National Radio Astronomy Observatory

April 30, 1981

Subject: Receivers Installation

A PROPOSED REPLACEMENT OF THE 12M REFLECTOR

Fig 1: Breceiver mounts are co-planar Location A is for the existing, & B for the new receivers $\frac{1}{50}$ scale

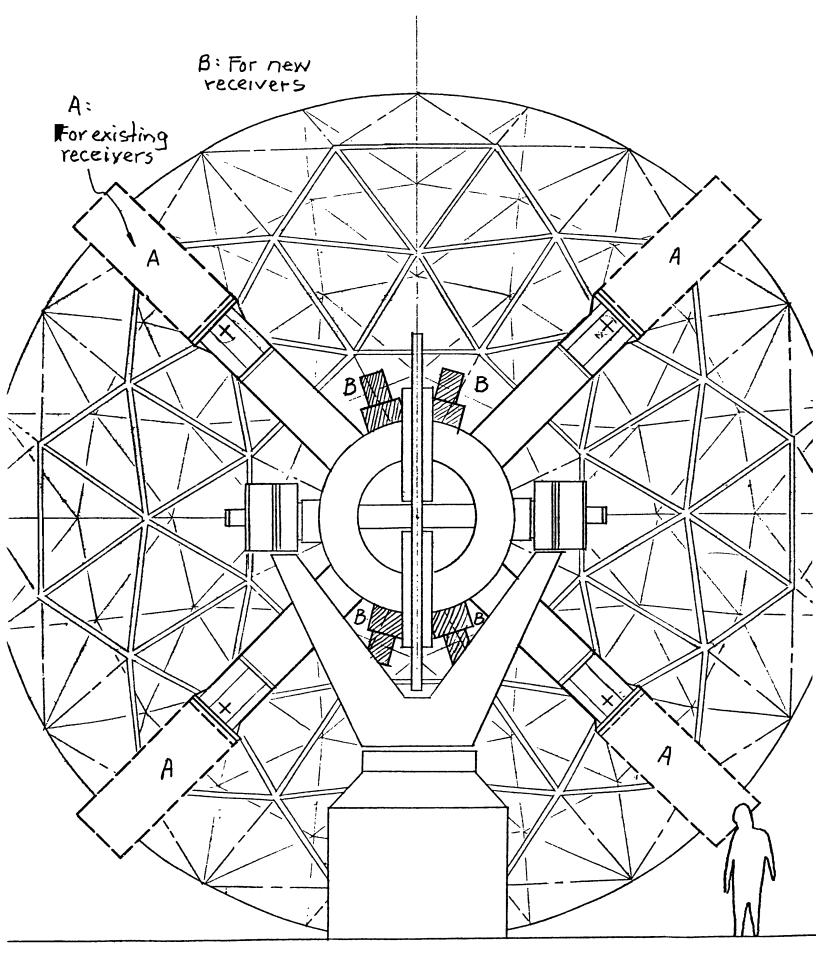
- 1) Four receiver mounts are located on the strong central hub, fitting the new 70-120, 130-170, 200-300 GHz receivers plus a dummy or spare, illustrated in Figure 1 as shaded area and Figure 3 in more detail.
- 2) Four receiver mounts are located on the end of the four supporting beams, outlined in Figure 1 and 2 as dotted area and shown in Figure 4 in more detail. These mounts are prepared for the existing receivers (if we have only two, it might need two dummys to balance the structure). The possibility of mounting these receivers there depends on the outcome of the structural analysis (not yet done in detail). For the gravity effect on the structure might cause unacceptable pointing problems. Or, as an alternative, an extra degree of correction might be needed to the selecting mirror to compensate for such systematic error.
